REGIONAL REVIEW NOTICE

ARC REVIEW CODE: R1610251

Name of Proposal: Vinings Atlanta

**VININGS ATLANTA DRI
Cobb County
Natural Resources Division Review Comments**

Conceptual Site Plan

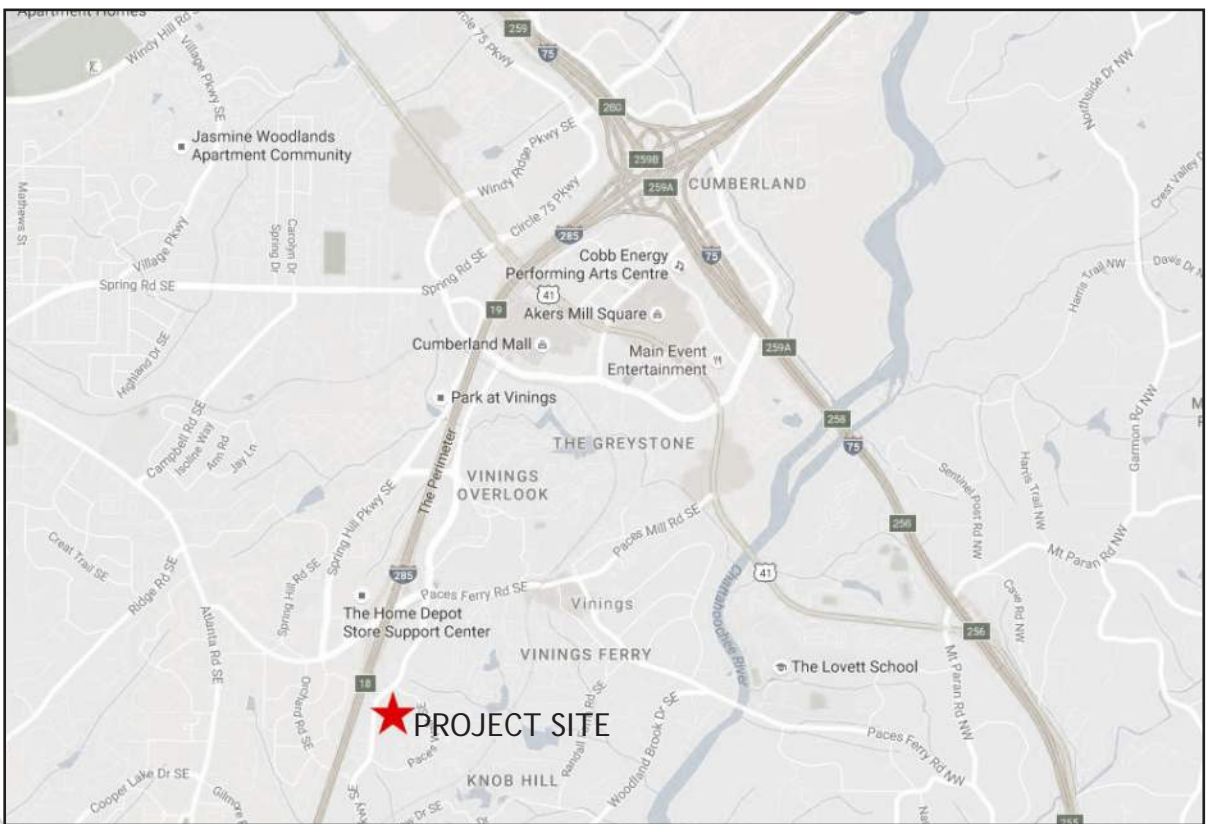
The project site abuts existing single and multifamily residential neighborhoods on the south and east sides. The proposed uses could serve the existing neighborhoods surrounding the project site. The conceptual plan does not depict proposed accommodations for inter-parcel connectivity for vehicles. This may be because of the layout of existing neighboring developments as well as the topographical variations in slope between adjoining parcels.

The site plan depicts proposed sidewalks throughout the development, providing for pedestrian intra-parcel accessibility throughout the site. The site plan and traffic analysis does not note separate facilities for vehicles and bicycles on site, however, proper accommodations may be proposed to allow for safe maneuvering of bicycle traffic commingled with vehicle traffic. The site is adjacent to existing

high density residential on the south side and on the north and east sides along Paces Walk. Paces Walk has no sidewalks along the roadway way connecting pedestrians to the site. In addition, no interparcel connectivity is proposed to the adjacent site.

Pedestrian facilities are provided along Cumberland Parkway adjacent to the project site which provide for pedestrian connectivity to adjoining parcels. The conceptual plan does not depict proposed accommodations for inter-parcel connectivity for pedestrians or bicycles. This may be because of the layout of existing neighboring developments as well as the topographical variations in slope between adjoining parcels. Although sidewalks may be provided along Paces Walk to accommodate pedestrians likely frequently the site, no facilities are presented on the site plan.

The proposed development depicts both residential and commercial uses. Parcels A, B and C propose some measure of commercial, retail or office uses, with Parcel A housing a grocery store underneath apartments. Significant freight traffic may be generated with mostly two to three axle freight carriers delivering on site to small retail stores and office uses. The grocery store is more likely to generate semi truck trailer traffic for deliveries. A loading area appears to be designated for deliveries to the grocery store. The plan does not depict separate travel lanes internal to the site or designate access points in an effort to separate bicycle and pedestrians from truck traffic to and from the site. Paces Walk is a local road which generally does not permit semi truck traffic, therefore truck traffic at this access point may be limited.

It is ARC policy to encourage inter parcel connectivity between developments whenever possible. If topographical conditions permit, sidewalks along Paces Walk connecting to the neighboring residential development should be considered. Designated entrance and exit points for freight carriers, as well as designated delivery hours, should be considered to minimize intermingling of truck and bicycle/pedestrian traffic, increasing safety for all modes.

Paces Walk is a local two lane road looping around to provide two access points to Cumberland Parkway. Paces Walk has no turn lanes. The access point to the project site is close to the access site of

the adjacent residential development. To increase safety and mobility of access to the site, limited use of the Paces Walk access point should be considered.
